RESPONSE TO REQUEST FOR ADDITIONAL INFORMATION

APR1400 Design Certification

Docket No. 52-046

RAI No.: 522-8633
SRP Section: 07.07 – Control Systems
Application Section: 7.7
Date of RAI Issue: 10/01/2016

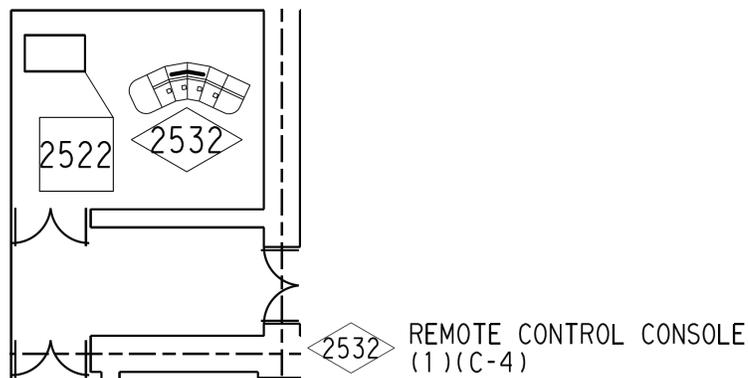
3. In its response, the applicant only refers to a single panel within the RCC. The exact physical configuration of the controls and displays remains unclear to the staff. Clarify whether the RCC provides all controls and displays on a single panel or on multiple panels.

3. The RCC accommodates MCR evacuation due to damage in the MCR. The RCC provides controls and displays needed for achieving hot shutdown of the plant, located on a single panel. The design of the ESCM in the RCC has the same shape as the ESCM in the MCR. The RCC is a sit-down console which includes four ESCMs, hardwired type P-CCS components switches, hardwired type indicators, voice communications and laydown space. The RCC arrangement is shown as follows:
